SAN LEANDRO UNIFIED SCHOOL DISTRICT
Facilities and Construction - Bond Department

To: Facilities and Technology Committee
Today's Date: 08/26/2020
From: Bond Department
F&T Meeting Date: 09/02/2020
Project Description: Washington Modular Classrooms

Change Order

Project: **Washington Modular Classrooms**
250 Dutton Ave.
San Leandro, CA 94577

INCREMENT 1 SINGLE LINE

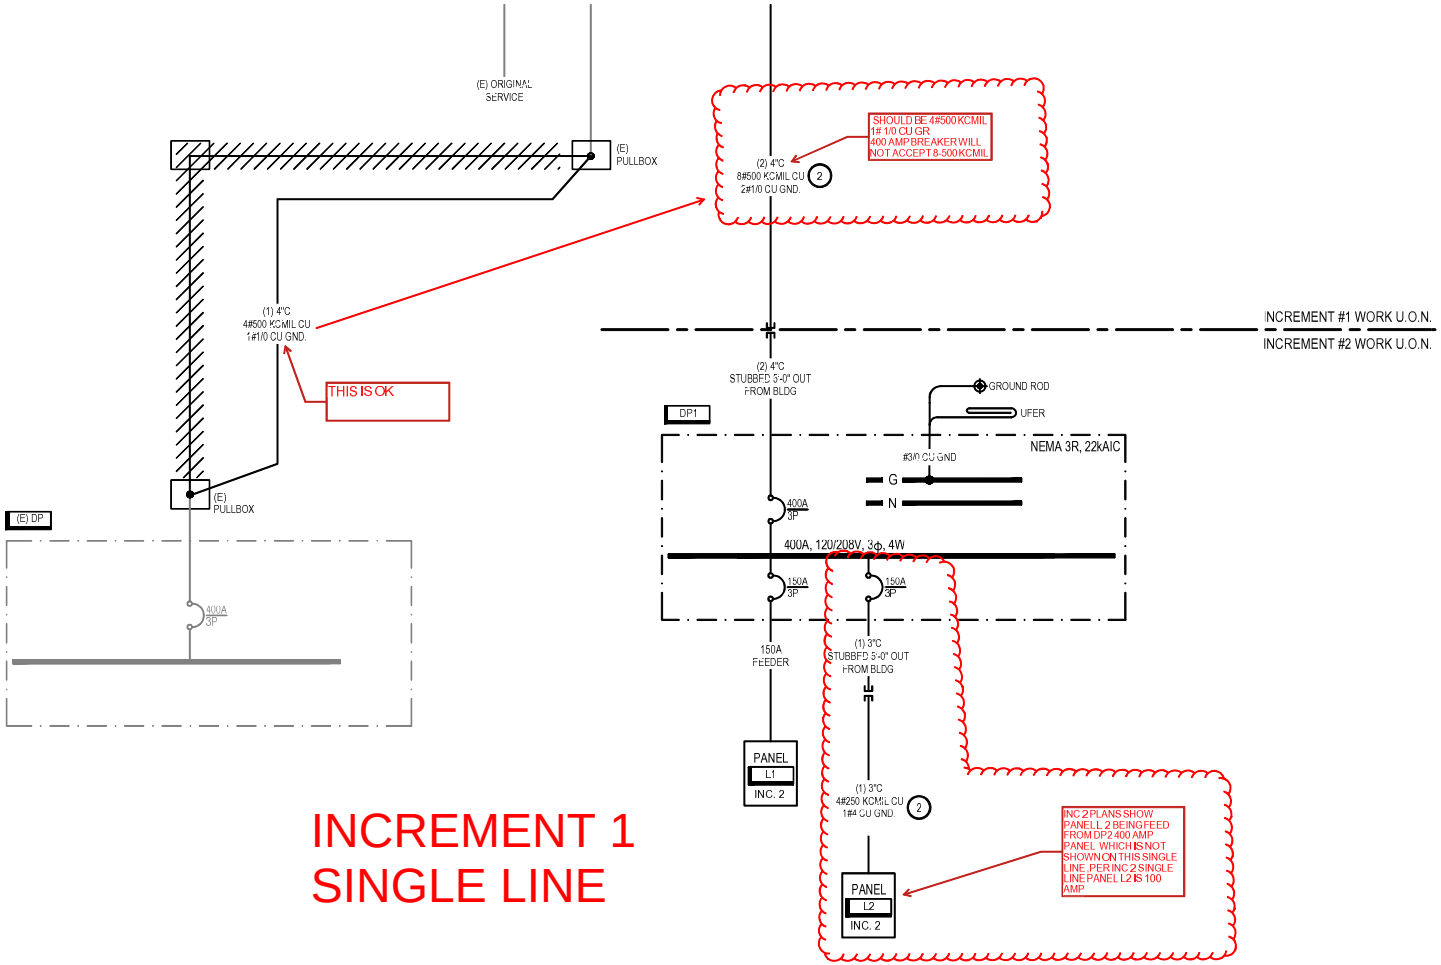
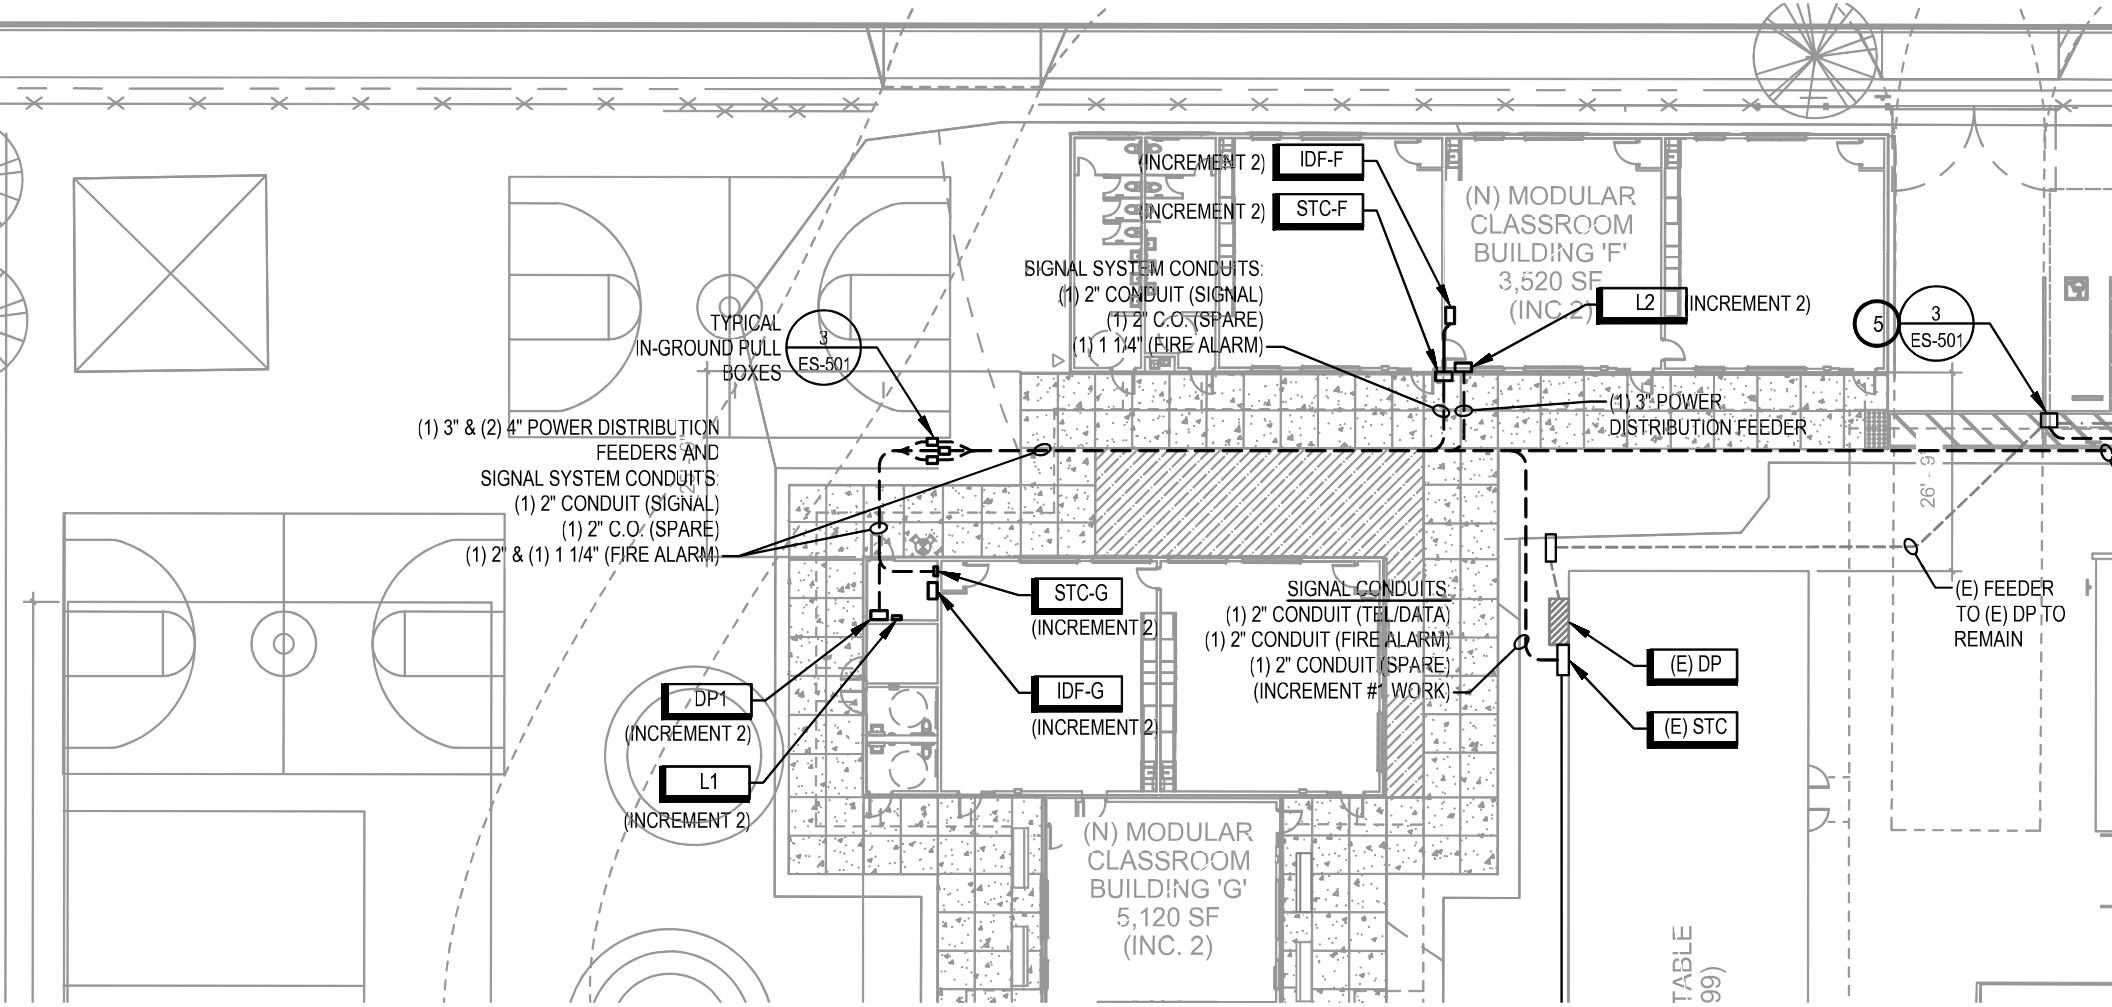
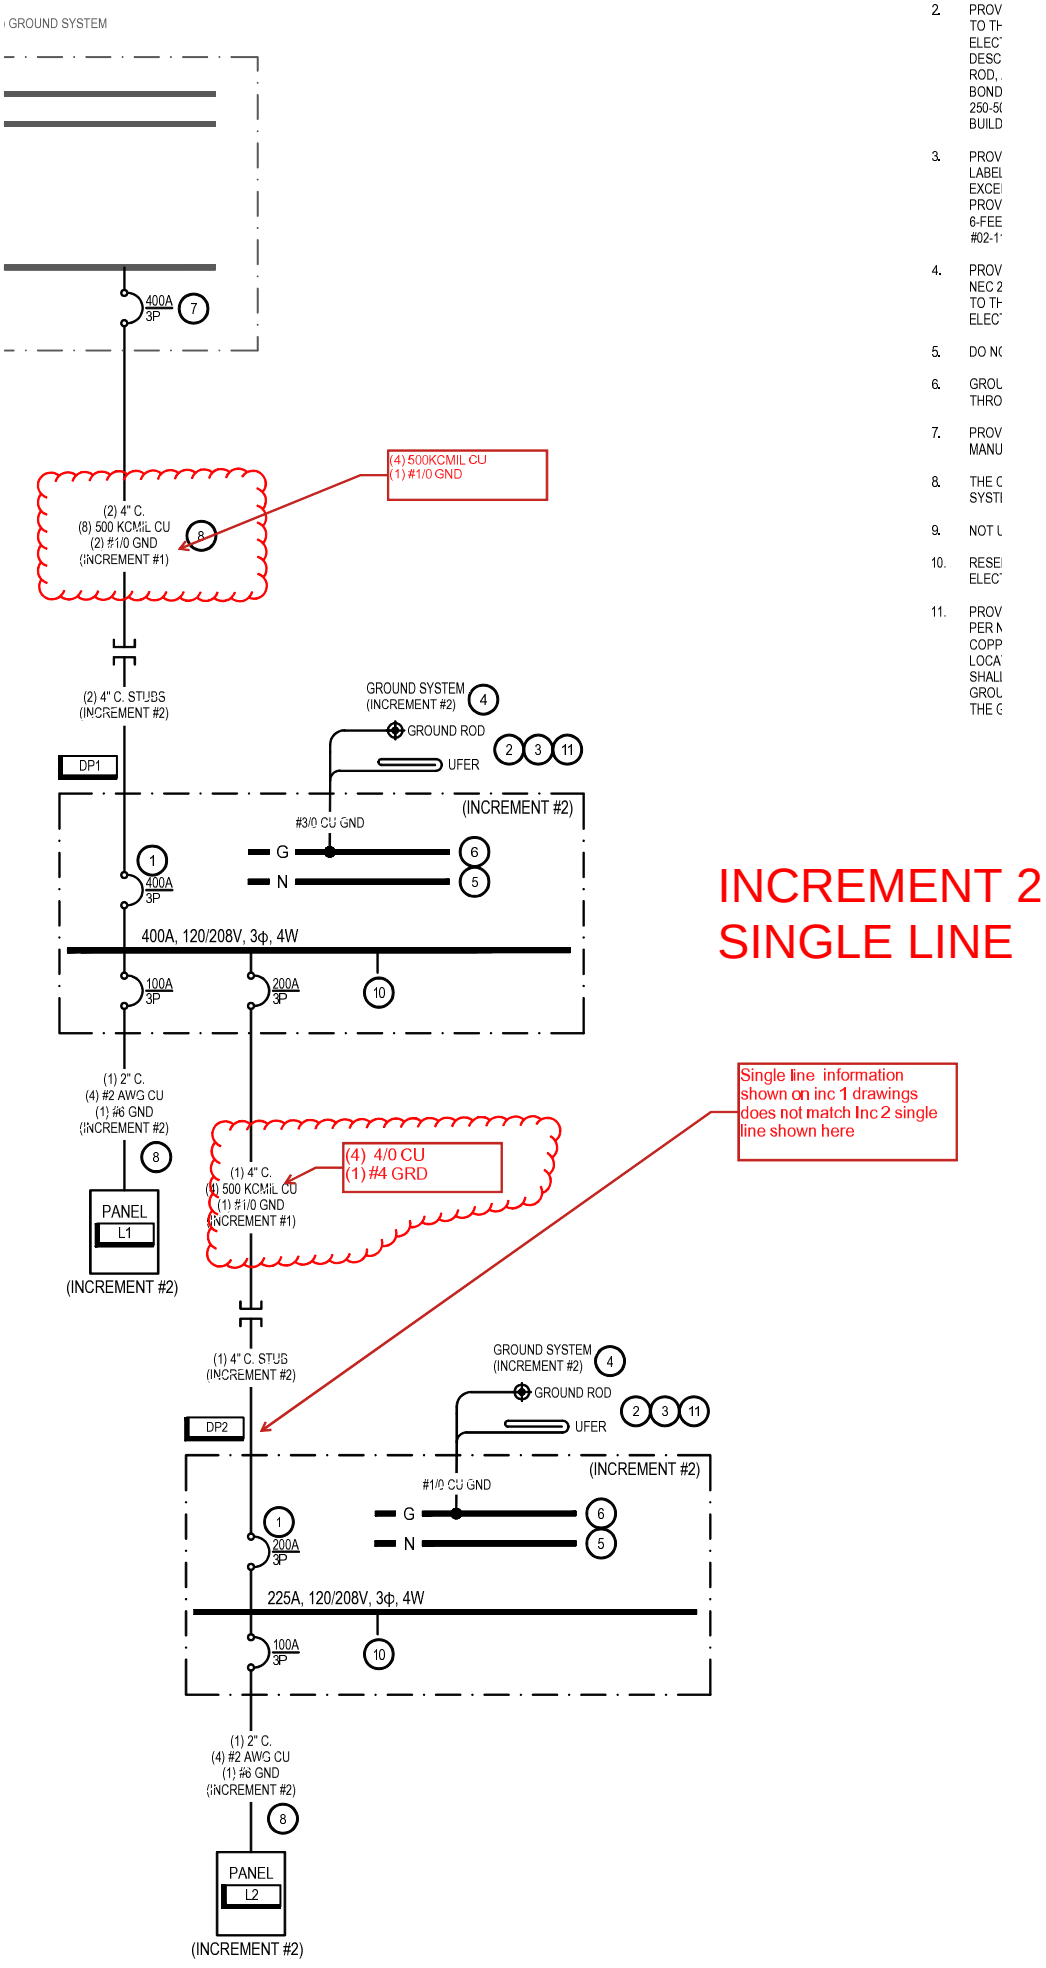
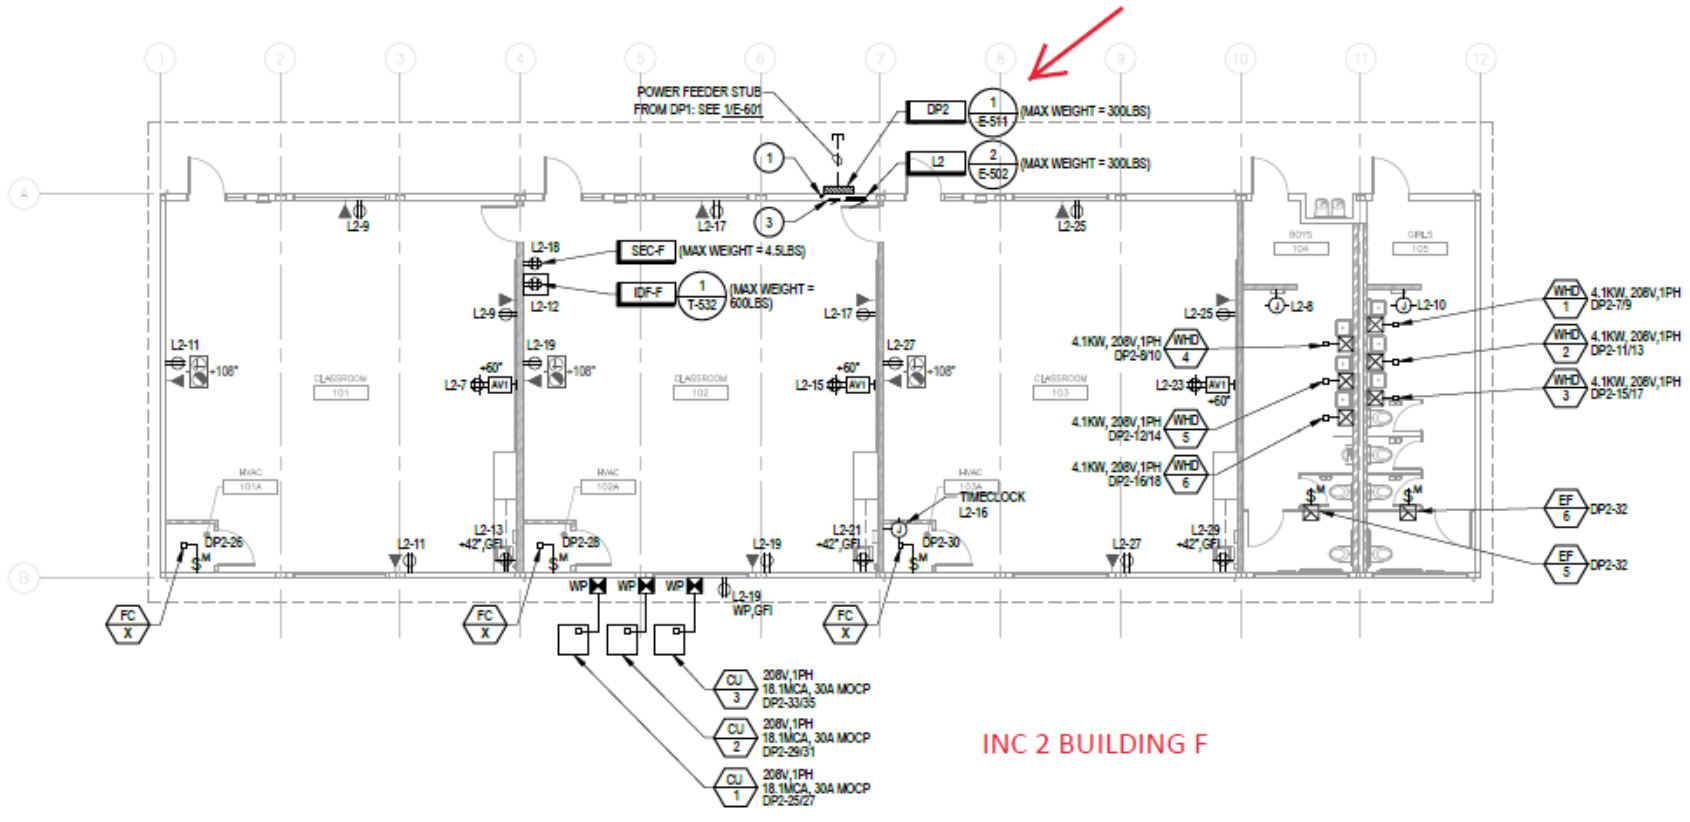
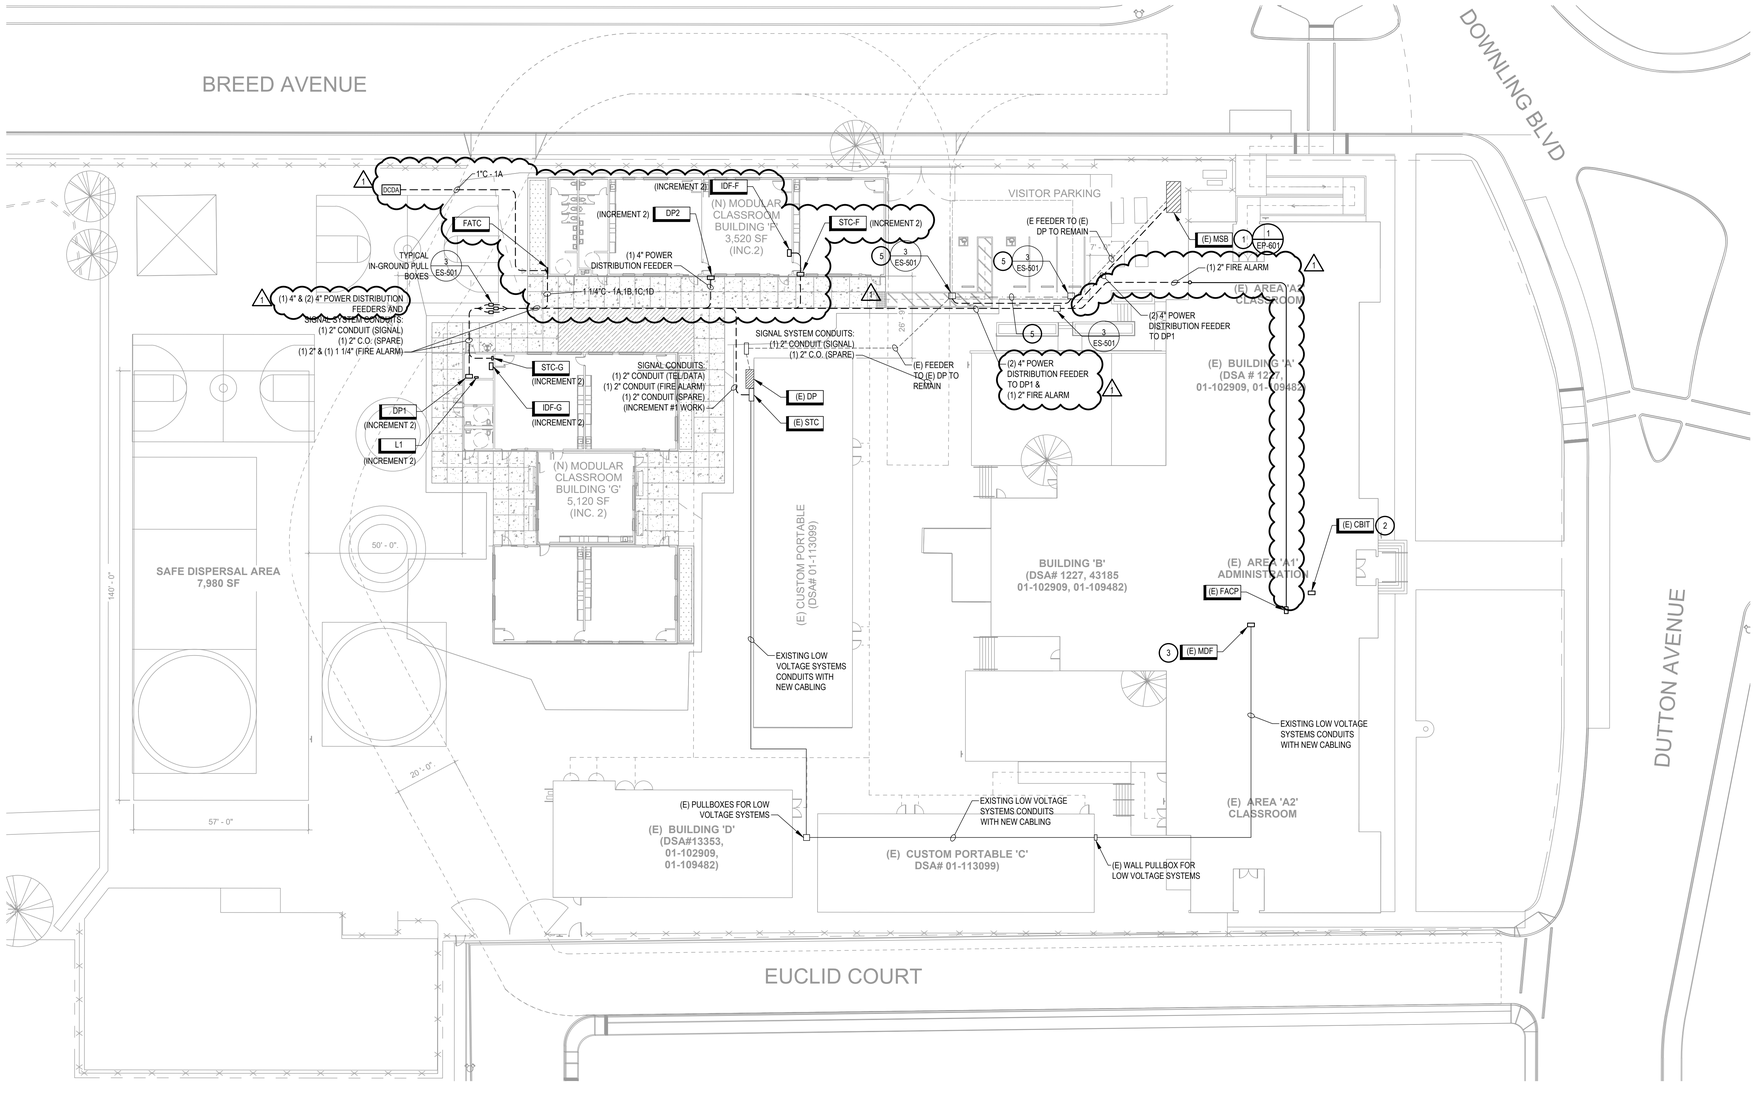
Subject: Electrical Panel & Wire Discrepancies

Inc.1 plans (single line and site plan) do not show panel DP2. Inc. 2 plans (single line and bldg F power plan) show panel DP2. Attached are the Inc 1 and Inc 2 single lines for comparison. We have also reviewed the proposed wire sizes and we suggest some wire size changes per the attached.

Panel DP2 was submitted and approved for Inc 2

Please have design team review attached notes/ changes and confirm acceptable.

Please see attached Delta 1 Site Plan for Increment #1 that shows Distribution Panel DP2. The revisionwas done in February, but doesn't seem to have made it to JLM. The single line diagram for Increment #2 is the correct single line diagram.The cable sizes need to remain as shown on the Increment #2 single line diagram due to voltage drop. Cable reducers or thru lugs will need to be provided.
